SERVICE BULLETIN

Service Bulletin No.: DAC1-24-07 Rev 0

Title: Replacement of Battery/EPU Relay Contactor

1. **ATA Code:** 2430
2. **Effectively:** DA20-C1 aircraft, Serial Numbers C0001 through C0625.
3. **General:** This Service Bulletin addresses the installation of the LAMAR relay contactor for the Battery and/or EPU relay in the DA20-C1.
4. **Compliance:** Compliance with this Service Bulletin is Optional.
5. **Approval:** Engineering data referenced or contained in this Service Bulletin is approved as part of the type design.
6. **Labor** For aircraft serial numbers C0001 to C0148 and C0150 approximately 2 hours will be required to accomplish the replacement of either battery or EPU relay contactor.

Figure 2: Relay Wire Modification

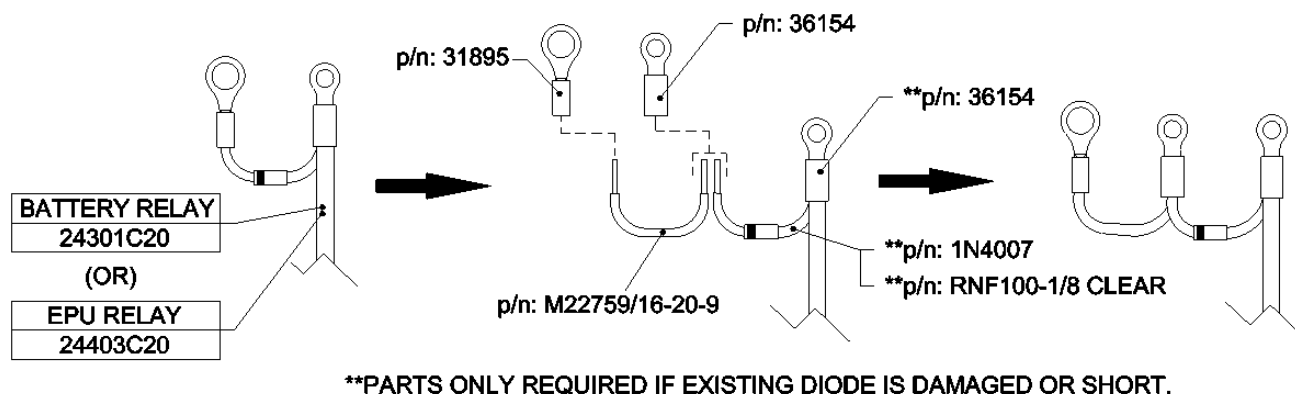
10.1.2 Rework the battery and/or EPU relay wires as shown in Figure 2.

Figure 3: EPU Relay Installation

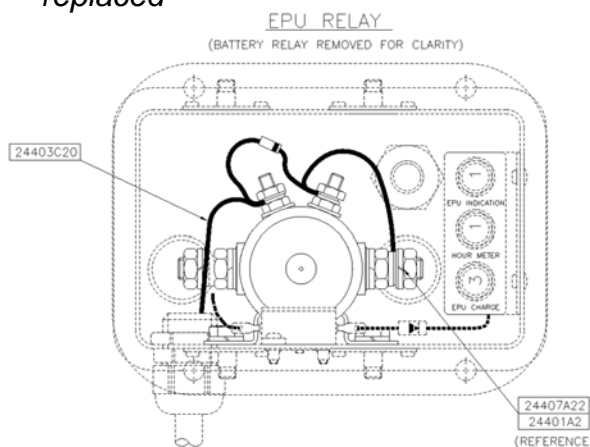
- 10.1.3** If only the battery relay is being replaced continue to step 10.1.6. If the EPU relay is being replaced continue to the next step.
- 10.1.4** Install the new EPU relay (P/N: X61-0028) using the supplied hardware (bolt P/N: AN4-4A, washer P/N: NAS1149F0463P) and cable ties (P/N: MS3367-4-9). Refer to AMM DA201-C1, Chapter 24-40-00 and Figure 3.

NOTE: Relay mounting tabs may need to be filed for proper fit. If filing was required apply suitable surface protection to all areas where filing has occurred (Nycote 7-11 or equivalent).

Figure 4: Battery Relay Installation

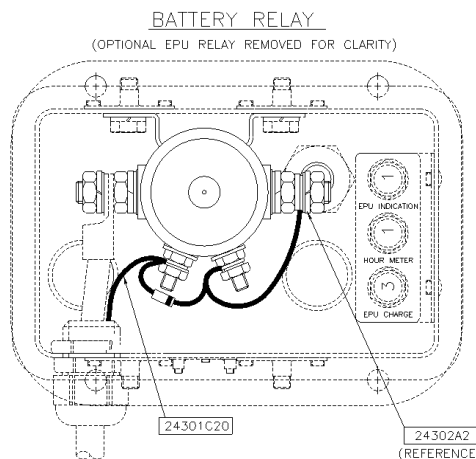
- 10.1.5 If the battery relay is being replaced continue to the next step. If not, continue to step 10.1.7.
- 10.1.6 Install the new battery relay contactor (P/N: X61-0028) using the supplied hardware (bolt P/N: AN4-4A, washer P/N: NAS1149F0463P) and cable ties (P/N: MS3367-4-9). Refer to AMM DA201-C1, Chapter 24-31-00 and Figure 4.

NOTE: Relay mounting tabs may need to be filed for proper fit.

Figure 6: Relay Wire Modification

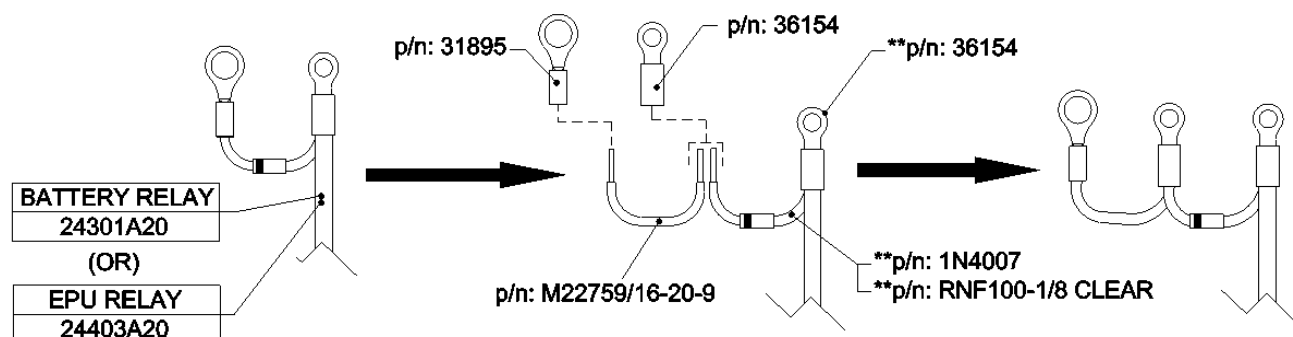
- 10.2.3 Disconnect the wires from the relay(s) being replaced. Remove the hardware and the relay(s) from the aircraft.
- 10.2.4 Rework the battery and/or EPU relay wires as shown in Figure 6.

****PARTS ONLY REQUIRED IF EXISTING DIODE IS DAMAGED OR SHORT.**

10.2.5.1 If only the battery relay is being replaced:

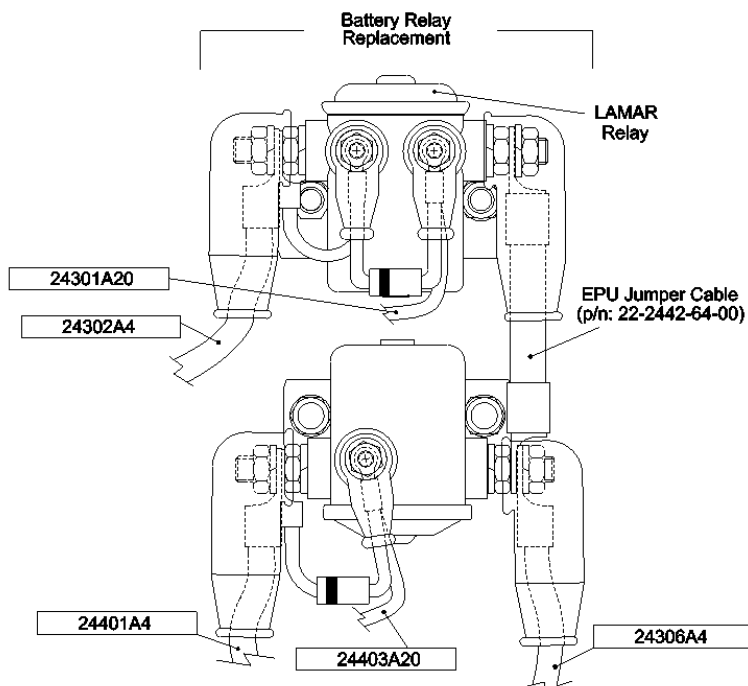
10.2.5 Install the relay contactor(s) as shown below and secure with the supplied cable ties (P/N: MS3367-4-9) and hardware (bolt P/N: AN4-6A, washer P/N: NAS1149F0463P, locknut P/N: MS21044N4).

NOTE: Relay mounting tabs may need to be filed for proper fit. If filing was required apply suitable surface protection to all areas where filing has occurred (Nycote 7-11 or equivalent).

NOTE: EPU relay is to be oriented downward.

NOTE: New Jumper EPU Cable is installed in place of bus bar.

10.2.5.2 If only the EPU relay is being replaced:

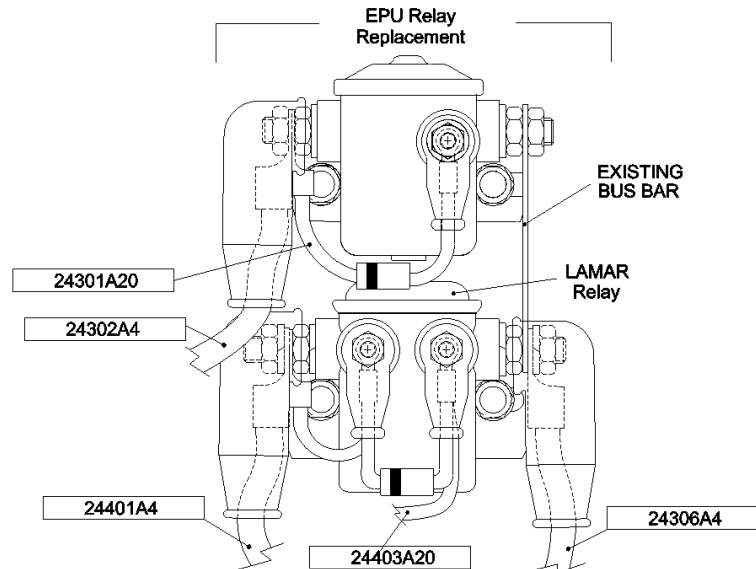
NOTE: Relay mounting tabs may need to be filed for proper fit. If filing was required apply suitable surface protection to all areas where filing has occurred (Nycote 7-11 or equivalent).

10.2.5.3 If both Battery and EPU relays are being replaced:

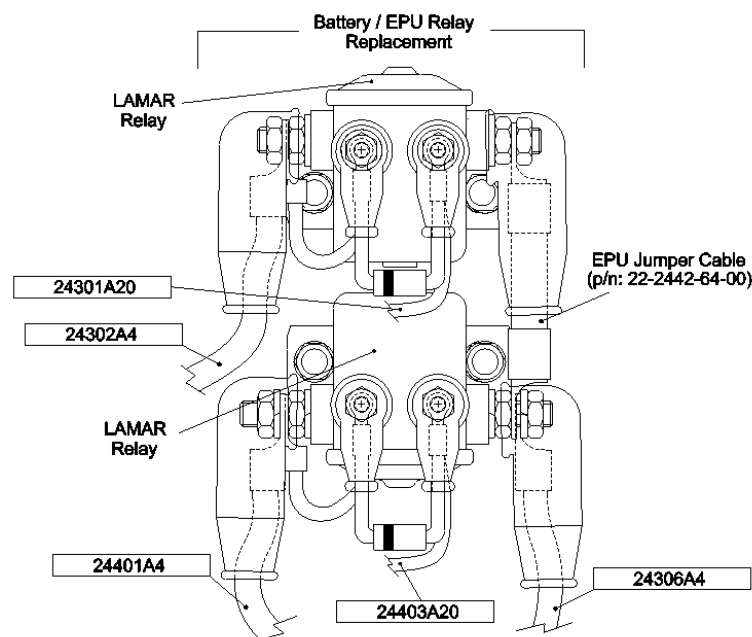
NOTE: Relay mounting tabs may need to be filed for proper fit. If filing was required apply suitable surface protection to all areas where filing has occurred (Nycote 7-11 or equivalent).

NOTE: EPU relay is to be oriented downward.

NOTE: New Jumper EPU Cable is installed in place of bus bar.
